OLD ORCHARD BEACH
January 2019
PLANNING BOARD
MEMO

ITEM 1

Proposal: Minor Subdivision: 2 Duplex Dwellings with a Total of 4 Residential Units
Action: Determination of Completeness; Schedule Site Walk; Schedule Public Hearing
Owner: Donald Bouchard
Location: 189 Saco Avenue, MBL: 208-3-12

Figure 1: New Proposal (January 2019)

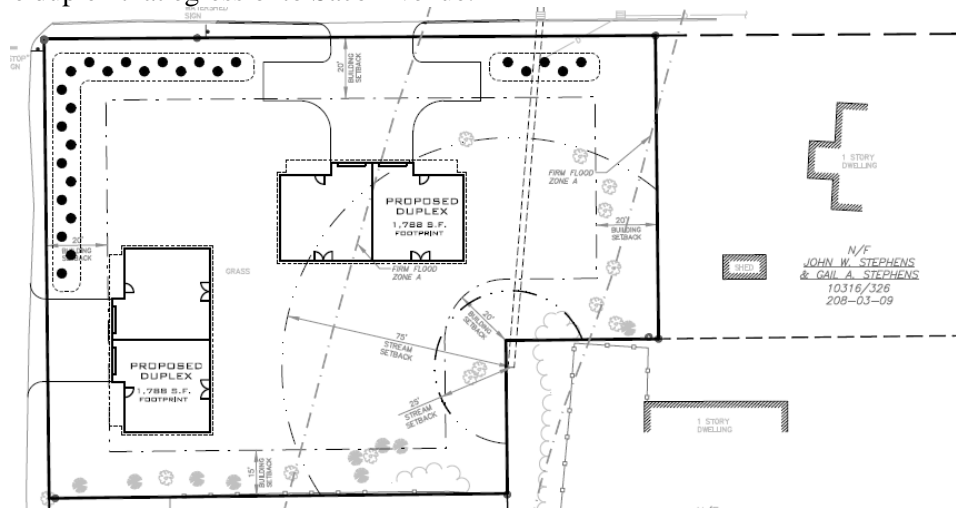
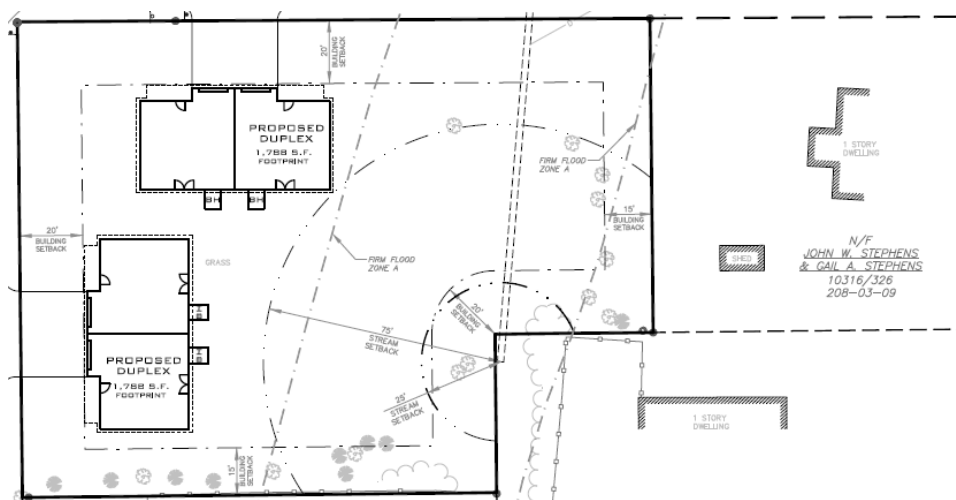
The Planning Board last saw this proposal back in August of 2018. It is for the construction of 2 duplexes on the corner of Macarthur Ave and Saco Ave. Below are the plans for the original vs. new proposal. The big difference is the addition of a t-turnaround for the duplex that egress onto Saco Avenue.

There was a concern regarding the proposed buffer location and sight distance. In the 2019 submission, they have incorporated an alternating pattern of arborvitaes and pushed them off the property line by 8 feet to alleviate this concern.

1. There is 1 waiver request associated with the 27 foot driveway width (Ordinance only allows for 20 feet).
2. The Applicant will need to obtain a variance for parking in the front setback on Macarthur.

3. No lighting has been proposed, the ordinance requires that this meet a certain standard. Should it be shown on the plan?
4. Is the PB all set with the alternating arborvitaes 8 feet off of the property line?

5. The PB will need to add a condition for one of the duplexes located in the floodplain.
6. Responses from the Applicant on the five floodplain standards.

7. The Applicant will need to address the outstanding Wright Pierce comments.
8. Formalization of a 30 foot easement to upgrade the 36-inch culvert adjacent to the property.

9. Planning Staff recommends the Applicant provide updated responses to the 14 Subdivision Criteria.
10. Planning Staff recommends the Applicant show snow storage locations on the plan for the turnaround area.
